ONE SYDNEY HARBOUR

STAGE 1B - Building R4B

SECTION 4.55

ARCHITECTURAL DRAWINGS

LEVEL	RL
Podium P1	8.400

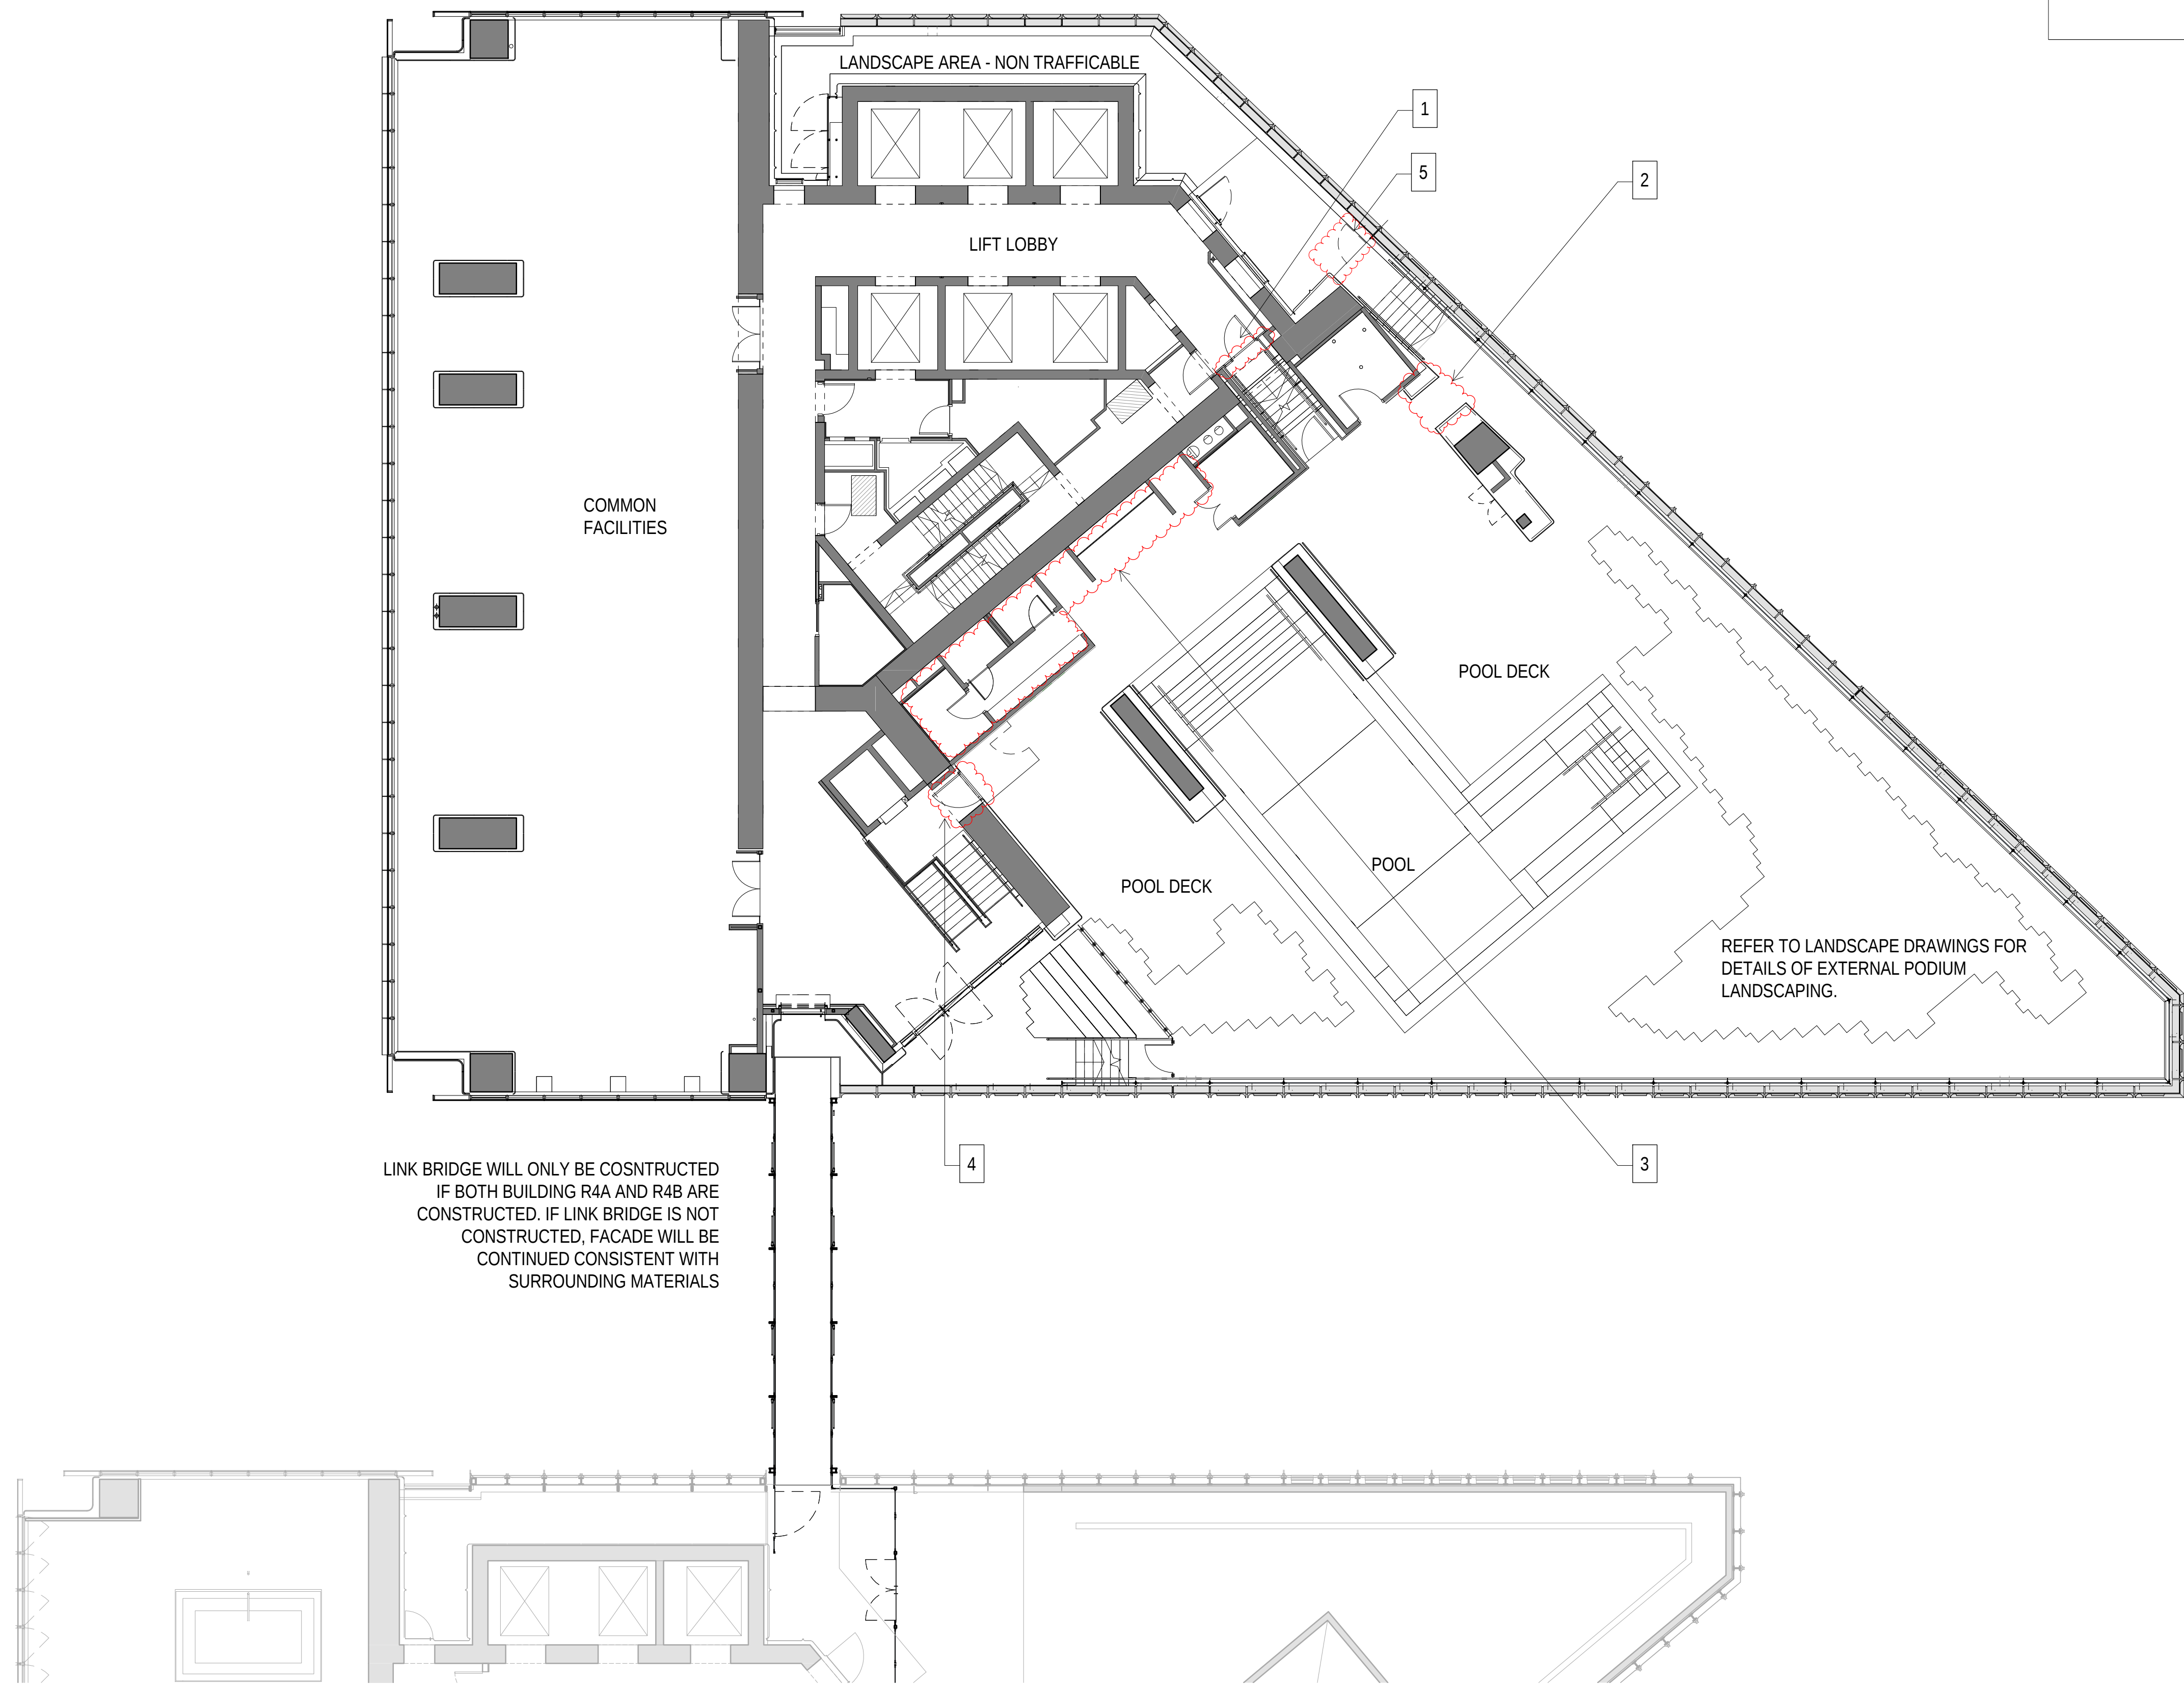
- MODIFICATION:**
1. DOOR ADJUSTED.
 2. AMENITY STAIR ADJUSTED, STORE ROOM REMOVED.
 3. SECOND EGRESS ADDED TO MEZZANINE PLANT.
 4. AWNING UPDATED.
 5. DOOR REMOVED.

LEVEL	RL
Podium P2	12.900

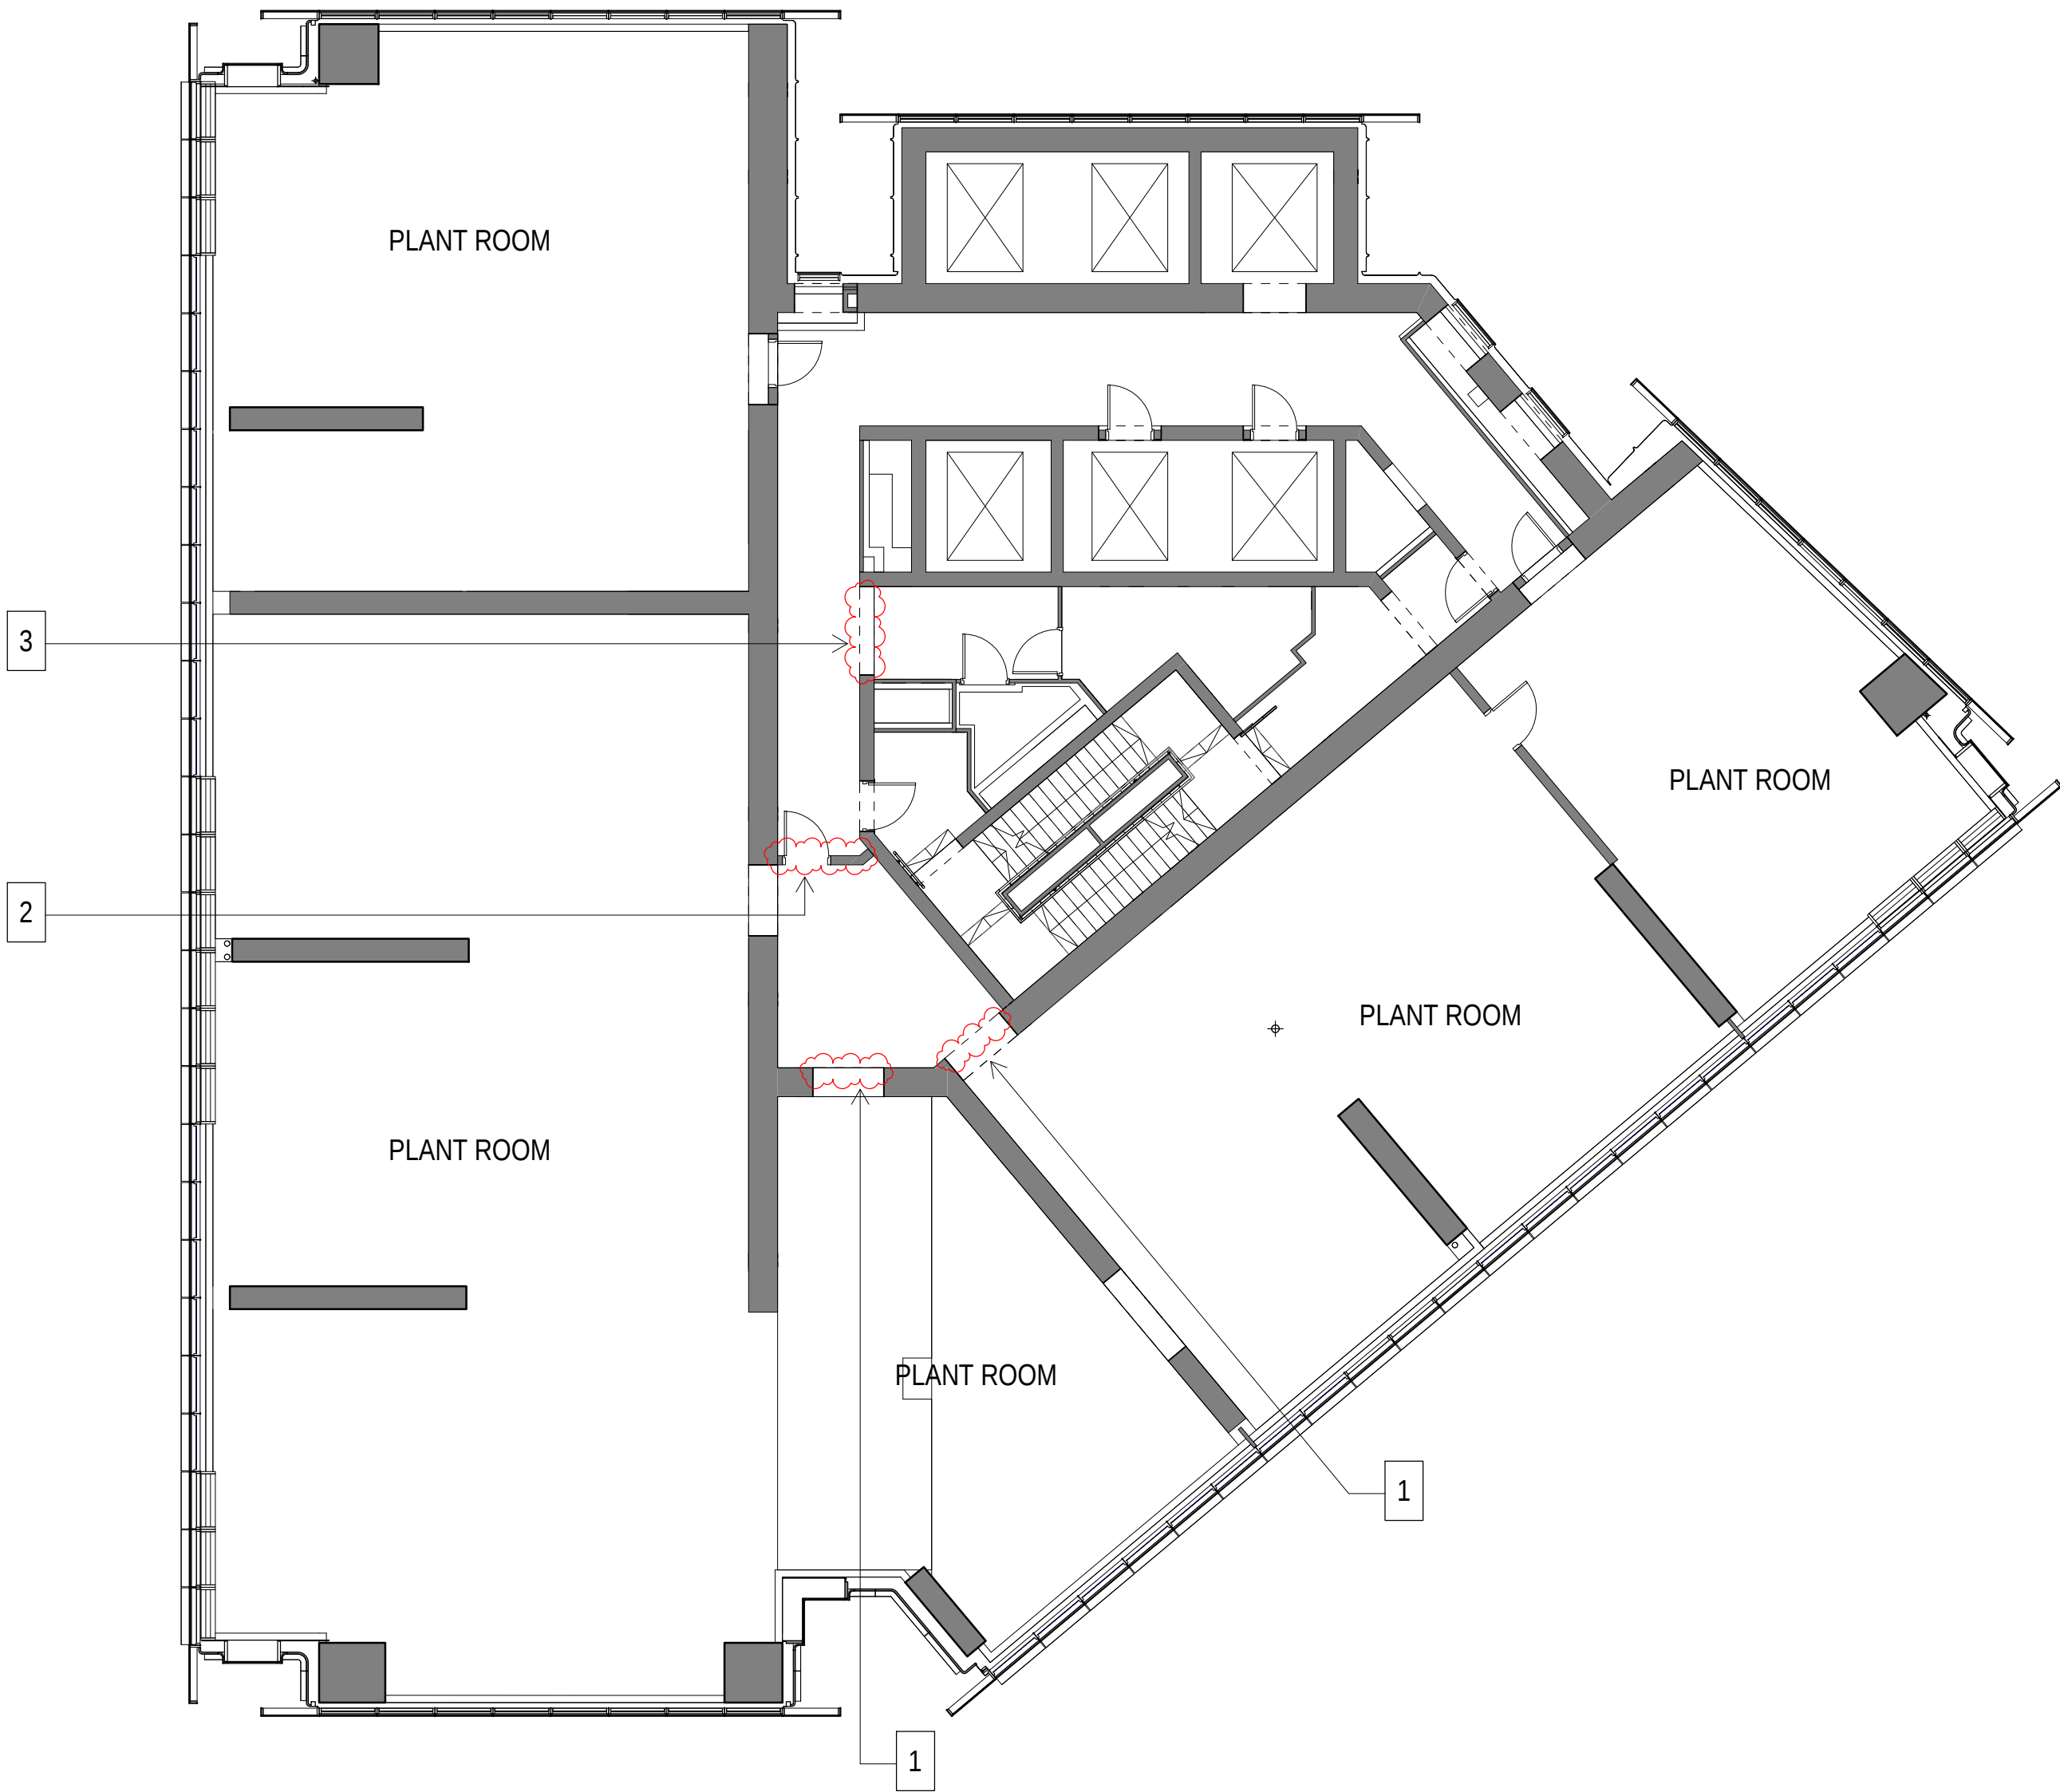
- MODIFICATION:**
- 1. SLIDING DOOR CHANGED TO SWING DOOR.
 - 2. FACADE UPDATED.
 - 3. SHOWER AREA AND AMENITY CHANGED.
 - 4. DOUBLE DOOR CHANGED TO SINGLE DOOR.
 - 5. DOUBLE GATE CHANGED TO SINGLE GATE.

LEVEL	RL
R4B L20	77.595

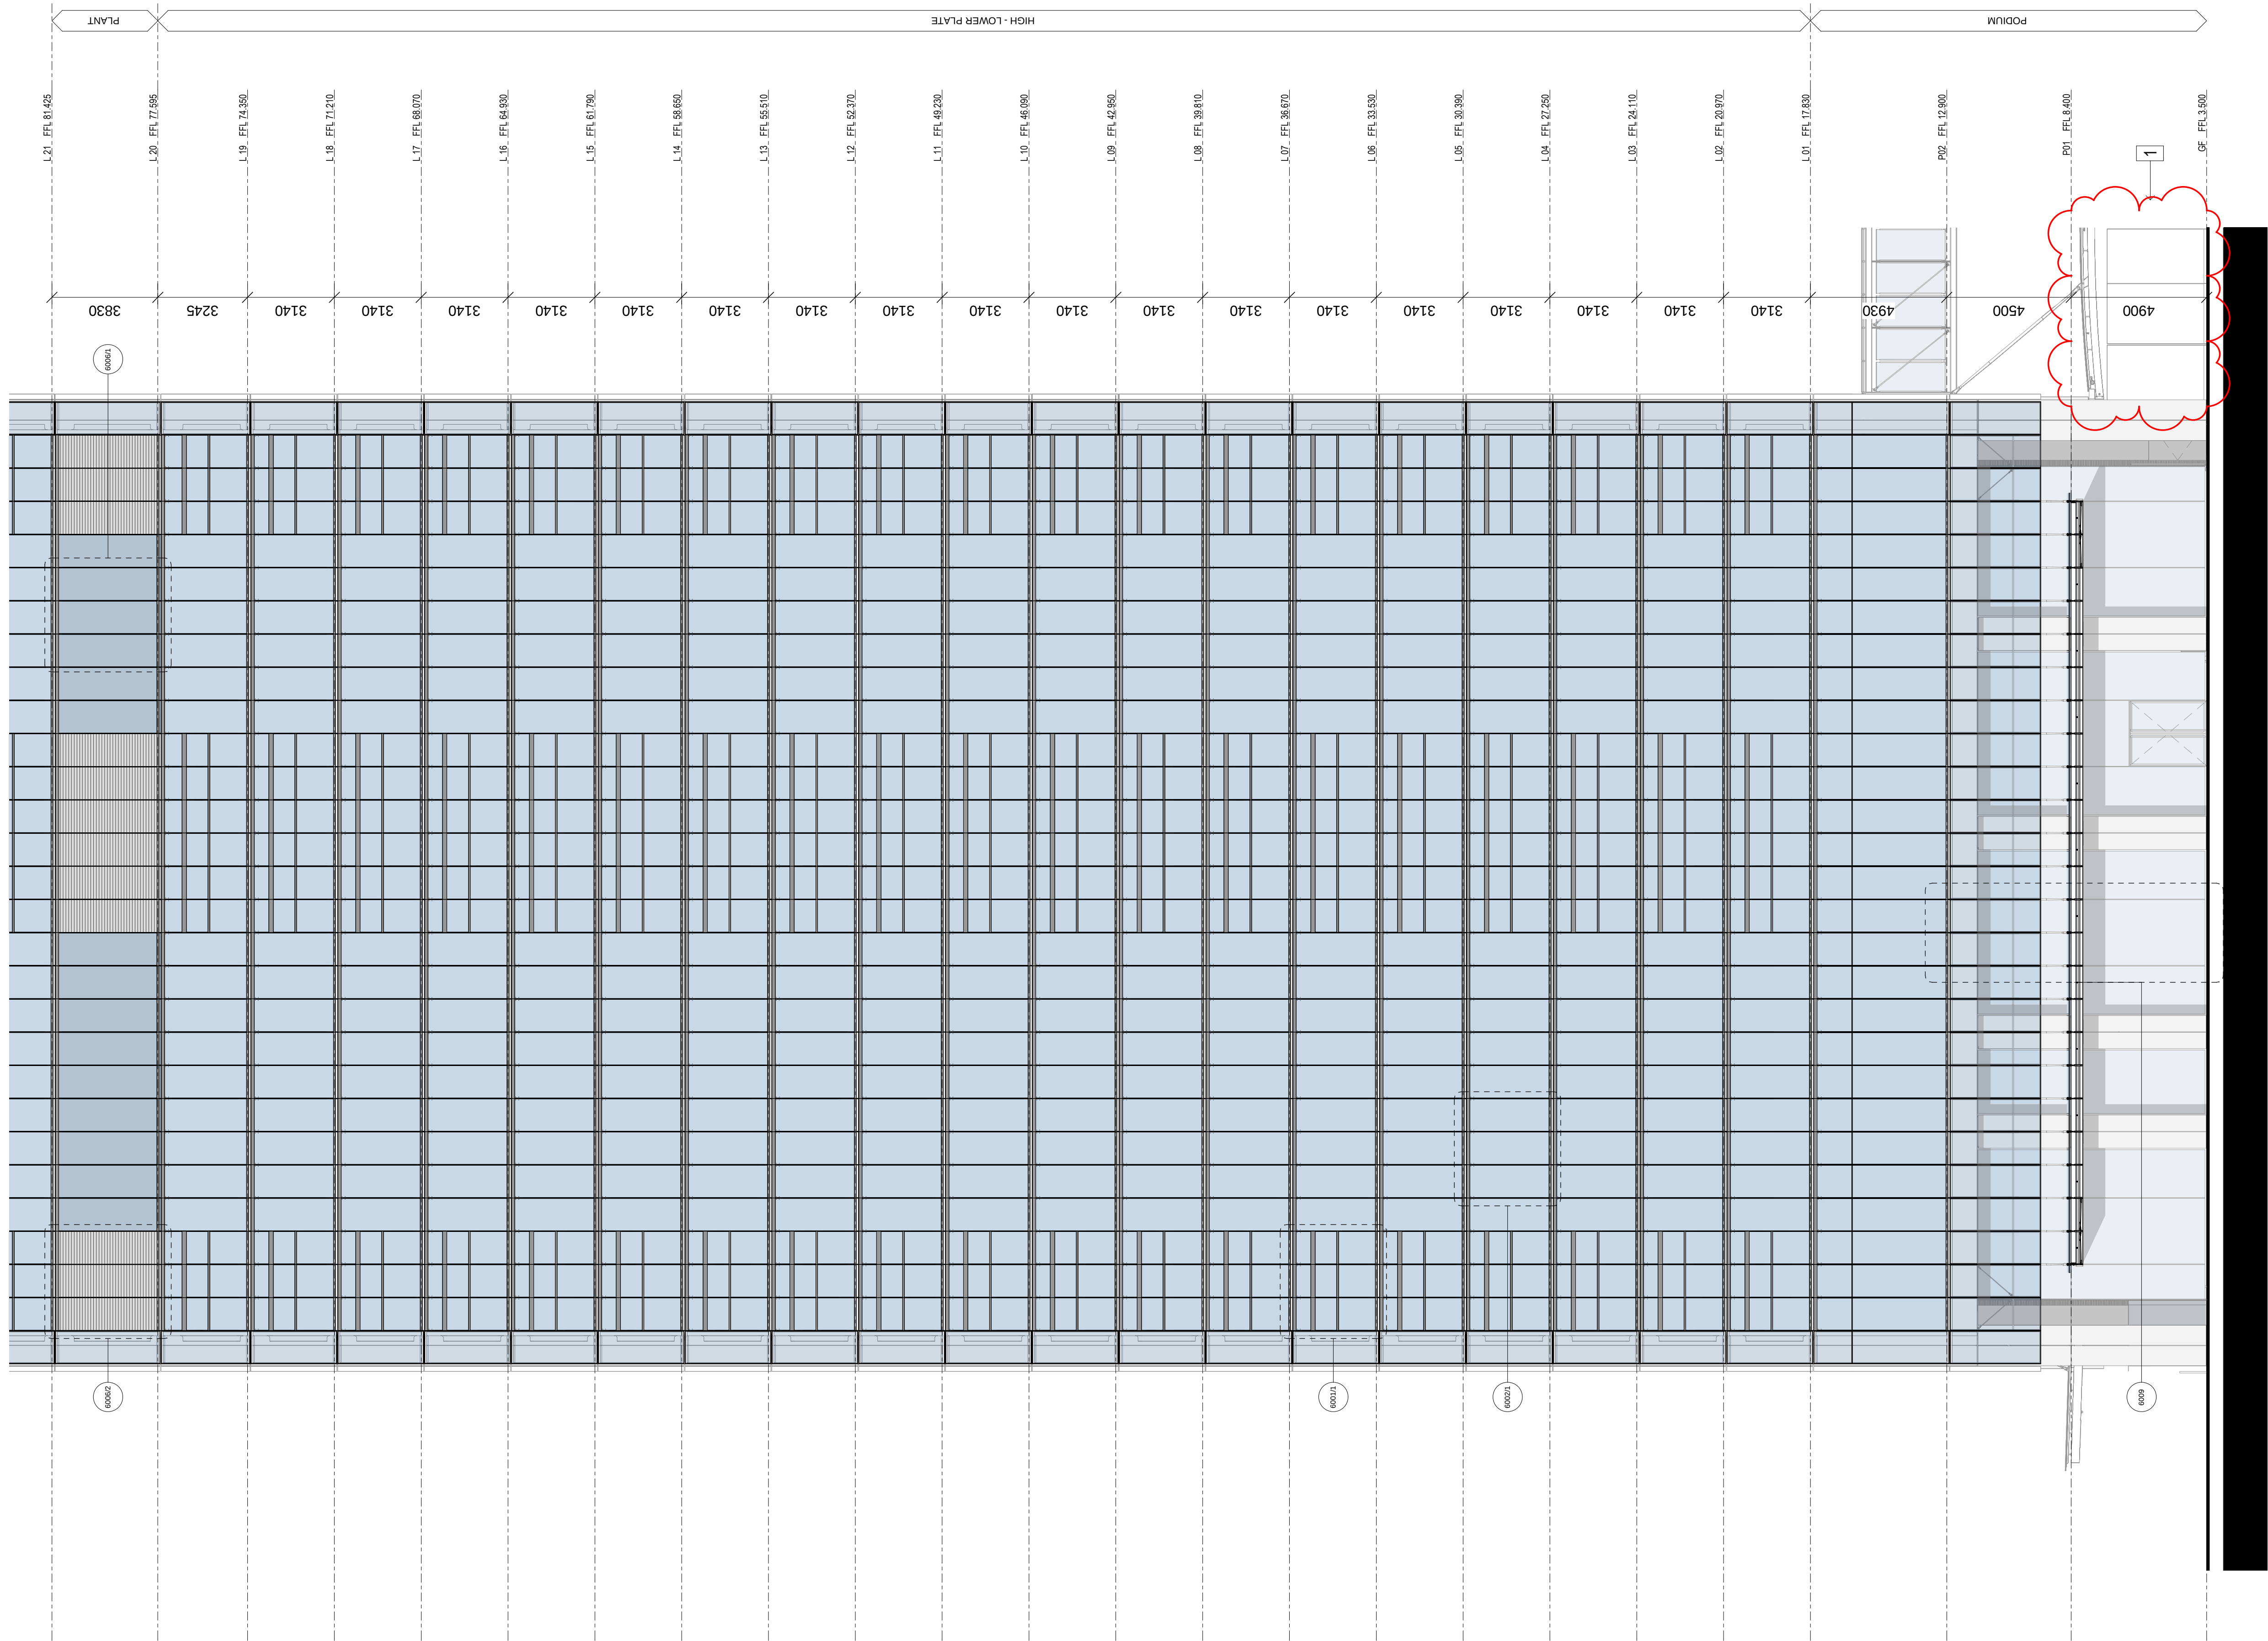
1. DOORS REMOVED.

2. WALL & DOOR ADDED.

3. WALL & DOOR REMOVED.
